## **NODD SUBDIVISION**

APPLICATION NUMBER 25 DATE April 7, 2005  
APPLICANT Nodd Subdivision  
REQUEST Subdivision

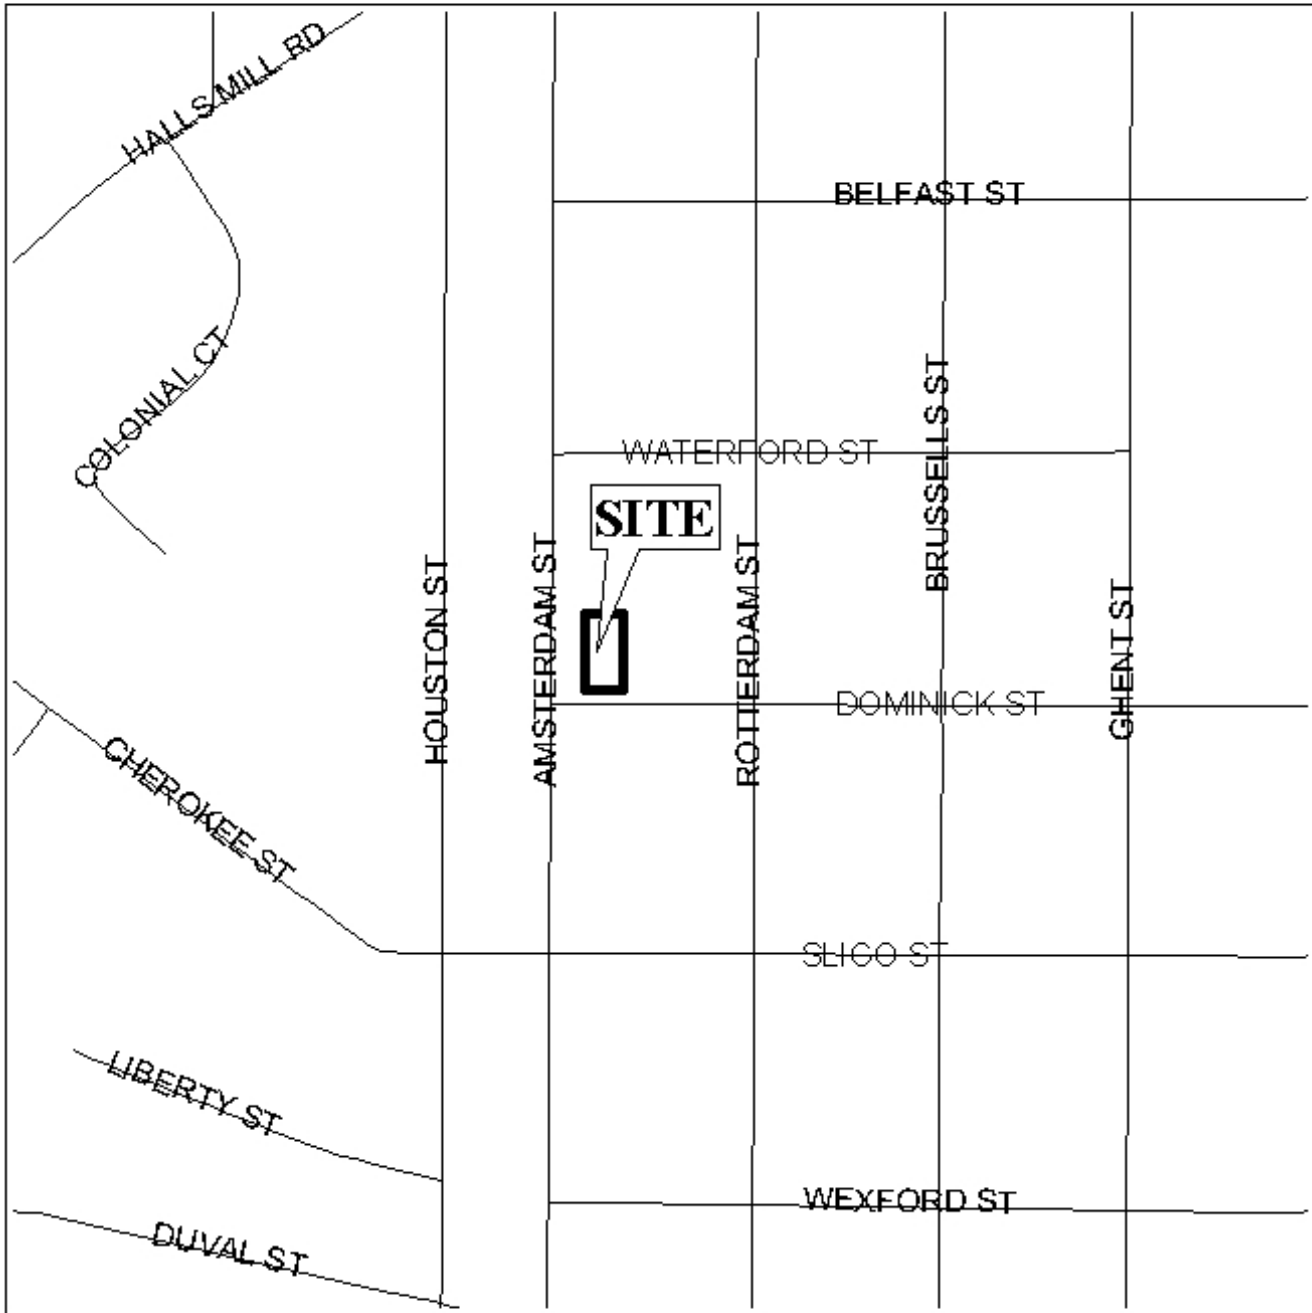
The plat illustrates the proposed 0.2± acre, 1 lot subdivision which is located at the Northeast corner of Amsterdam Street and Dominick Street and is in Council District 3. The site is served by public water and sanitary sewer.

The purpose of the application is the resubdivision of an existing lot of record, to exclude a portion of that lot which is occupied by a neighbor's house. Urban Development staff contacted the surveyor who stated that the neighbor does not wish to participate in the subdivision. A letter to this effect should be required. It should be noted that the excluded portion of the lot is approximately 33' in width, and would not meet the minimum standards for creation of a new lot; thus it will be the neighbor's responsibility to resubdivide in the future, should any improvements to their property be desired.

The site fronts Dominick Street, which has an existing right-of-way of 40', and as such is substandard in width; thus dedication of sufficient right-of-way to provide 25 feet from the centerlines of Dominick Street should be required. The site also fronts Amsterdam Street, which has an existing right-of-way of 40', and as such is substandard and width; however, the required 25' from the centerline to the property is provided, so no dedication is required. It should be noted that the City executed a Quit Claim Deed for a portion of land approximately 27' wide in the right-of-way of Amsterdam Street; this was incorporated into the site in 2001.

The required 25' building setback lines from Amsterdam and Dominick Streets are not shown but would be required on the final plat.

The plat meets the minimum requirements of the Subdivision Regulations and is recommended for Tentative Approval, subject to the following conditions: 1) the dedication of sufficient right-of-way to provide 25 feet from the centerline of Dominick Street; and 2) the depiction of the 25' building setback lines on the final plat.
